AGENDA WYOMING PLANNING COMMISSION TUESDAY, OCTOBER 21, 2025 7:00 P.M.

WYOMING PLANNING COMMISSION AGENDA ITEM NO. 1

ACTION REQUESTED: Request for Site Plan Approval

REQUESTED BY: Metropolitan Hospital and Land-Metro LLC.

WATER AND SANITARY UTILITY PLAN WEST

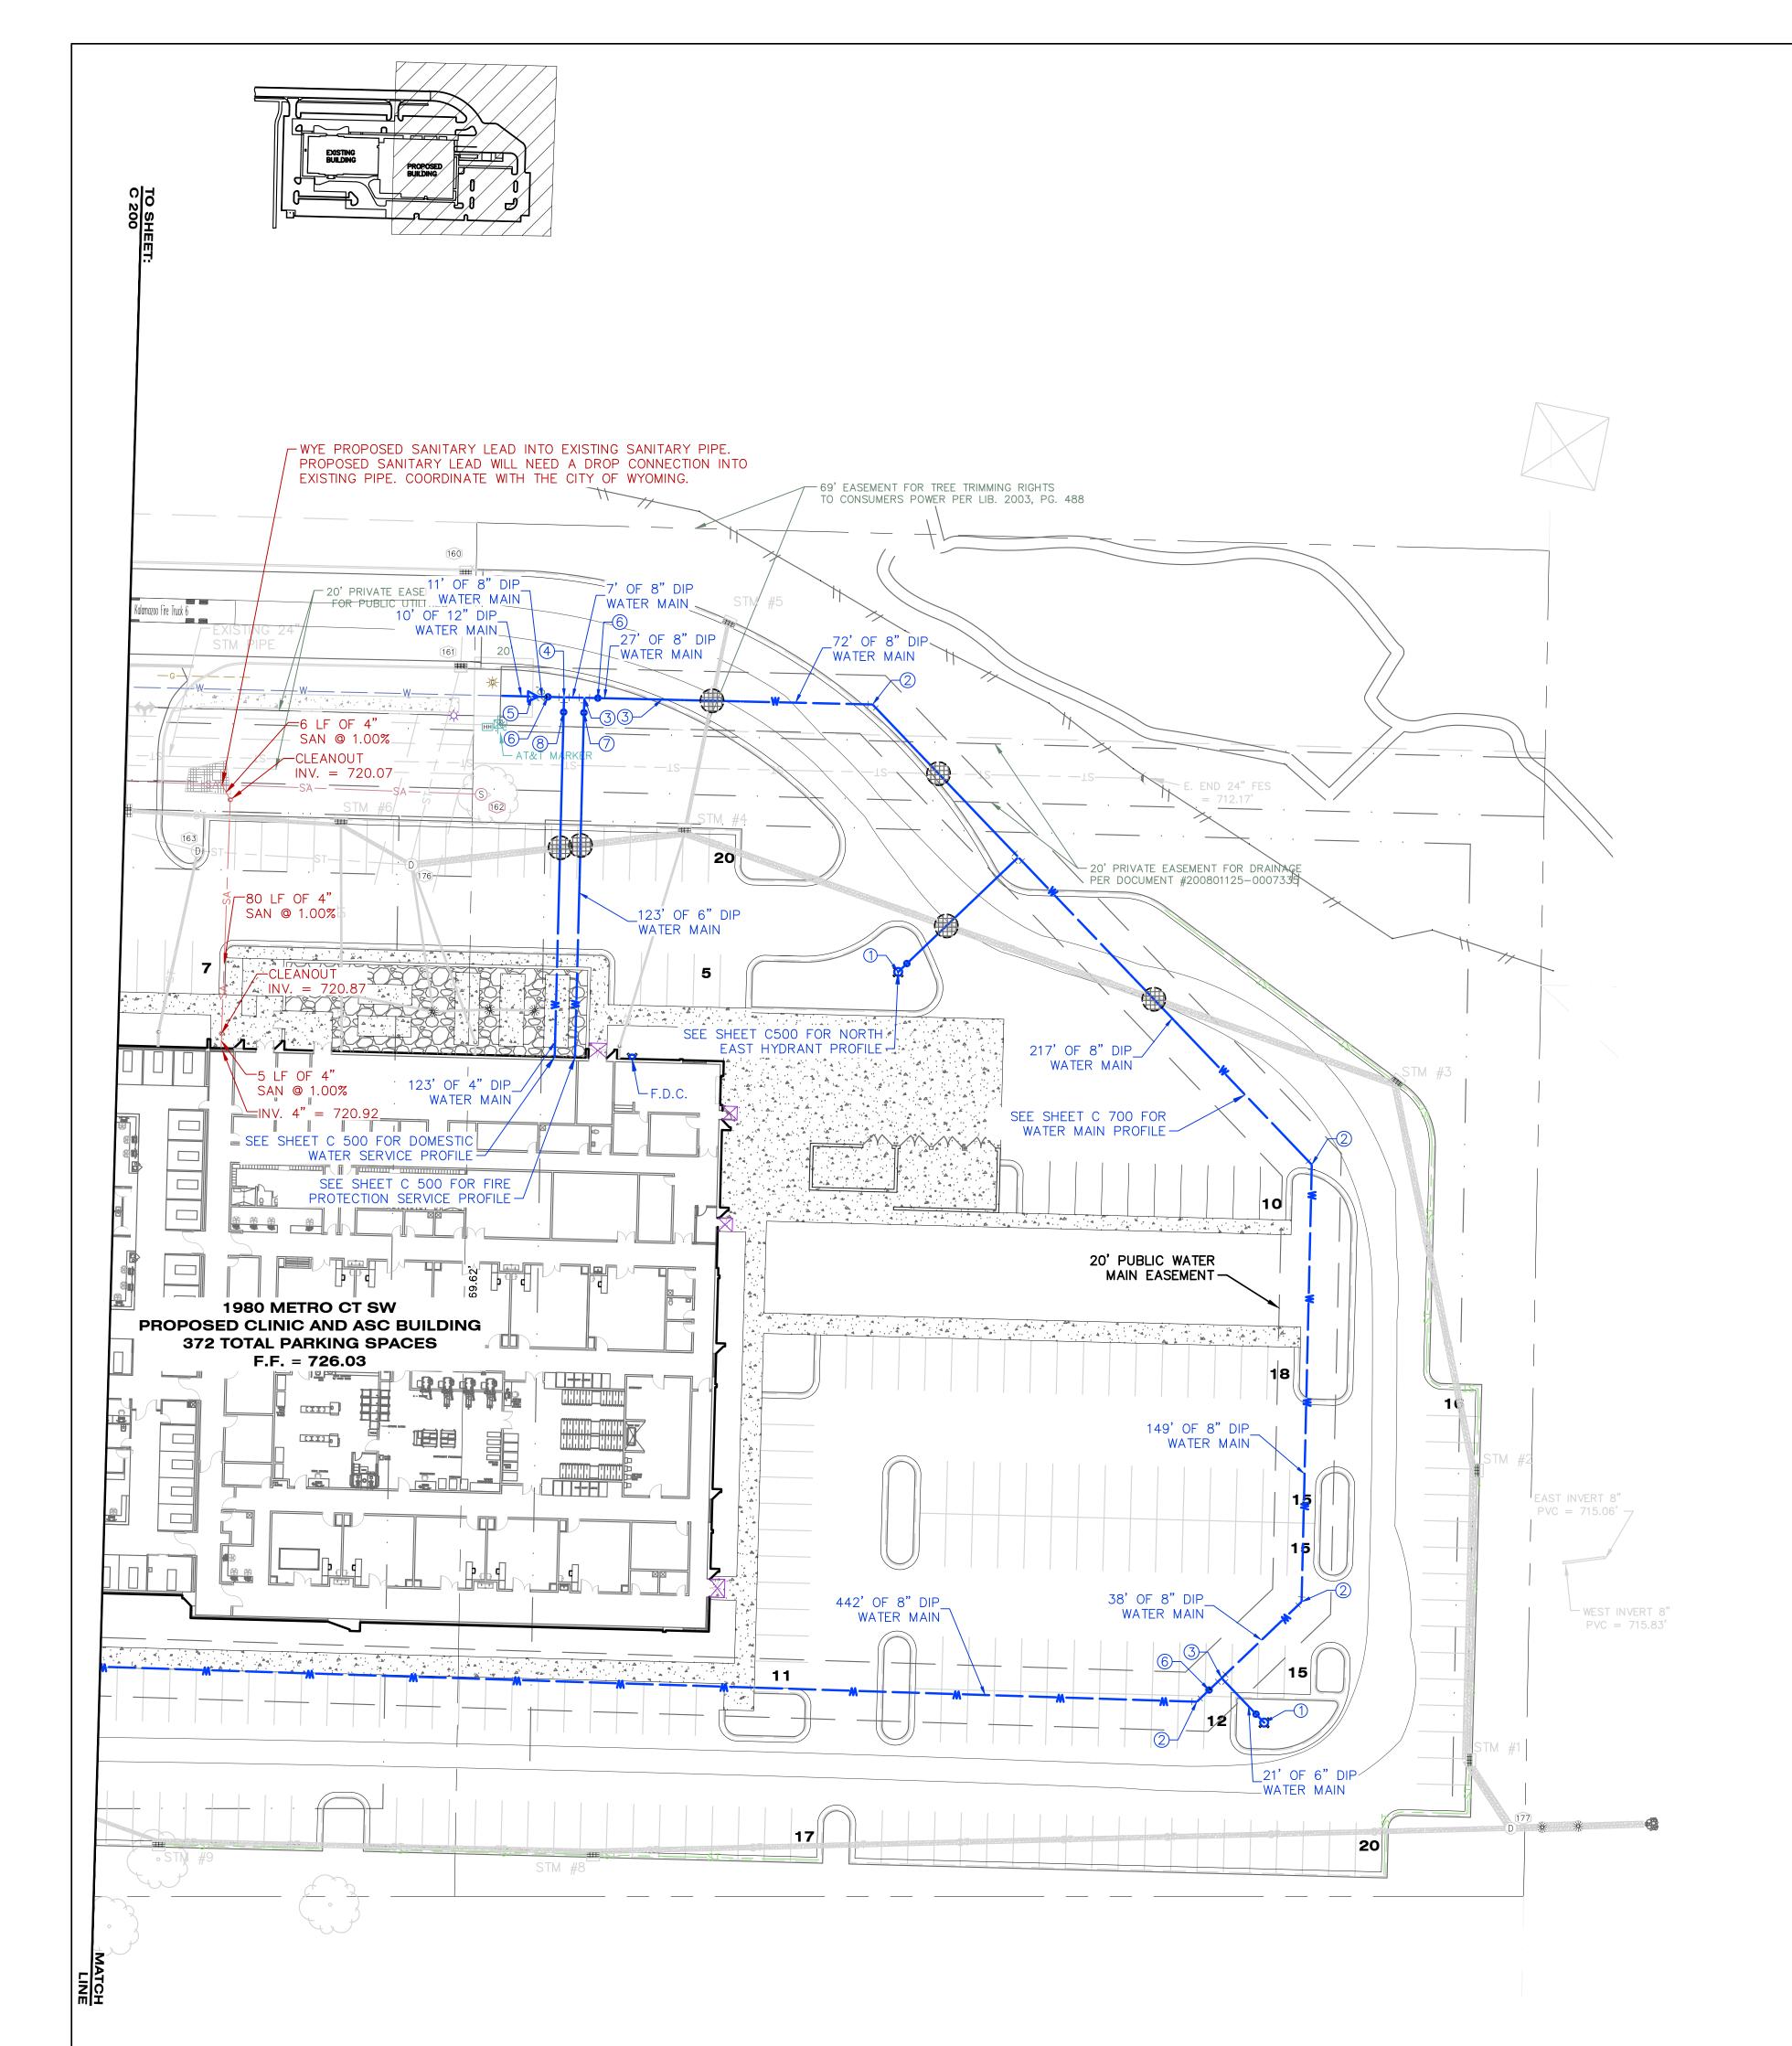
- f) Provide detail of connection between proposed watermain and existing 8" watermain

- g) Provide easement over existing 8" watermain. The creation of a looped system requires the existing 8" become public.
- h) Show watermain restraint lengths

- i) Deflect watermain under storm sewer, where practical, to provide required clearance. Use 45 degree bends where necessary.
- j) Provide plan note specifying that sanitary sewer lateral top on existing main shall be per City of Wyoming standards and a mainline riser shall be installed.

STORMWATER UTILITY PLAN WEST

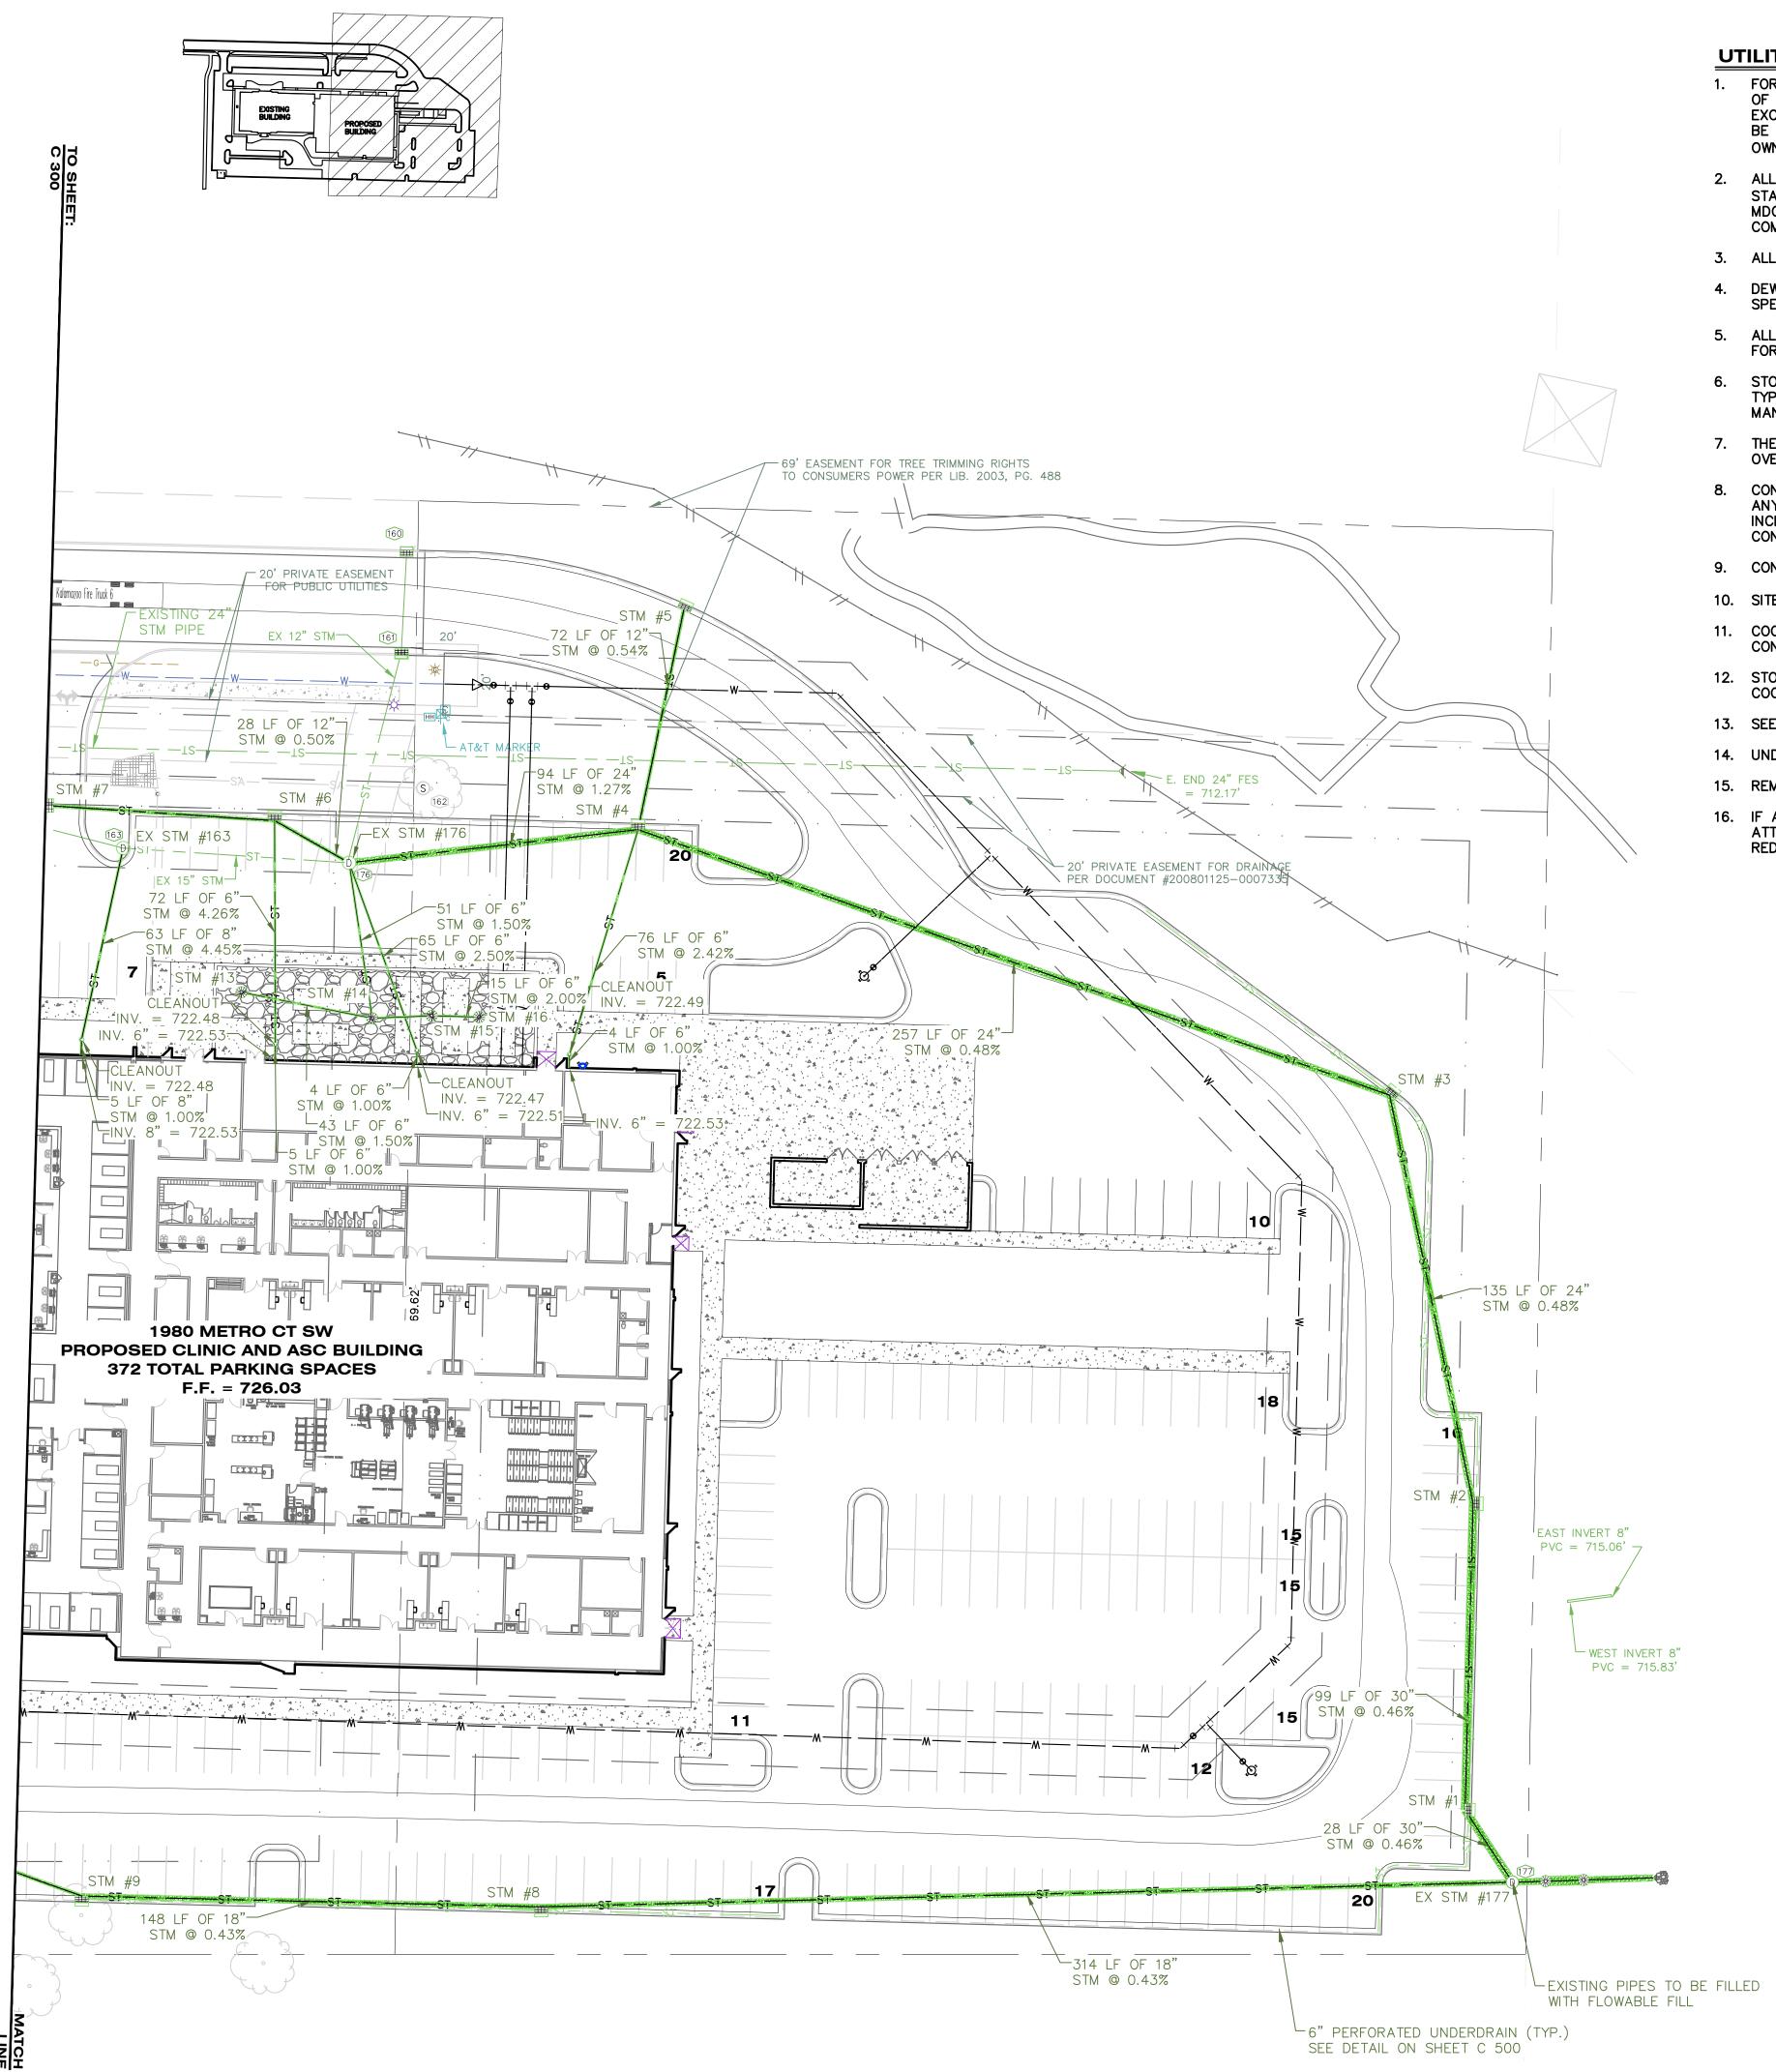
- Lengths between fittings for fireline(s).
- m) System Development, Waterservice installation, Meter and other fees will be required.
- n) Provide 3 feet of cover over storm sewer where feasible.

- o) Provide the following for stormwater calculations:
 - Completed LGROW spreadsheet detailing water quality and channel protection requirements for the site. Flood control may also be required, but is dependent on the sizing of the existing detention basin. Use design calculations provided by the City to determine whether the existing basin has enough flood capacity for the proposed site.
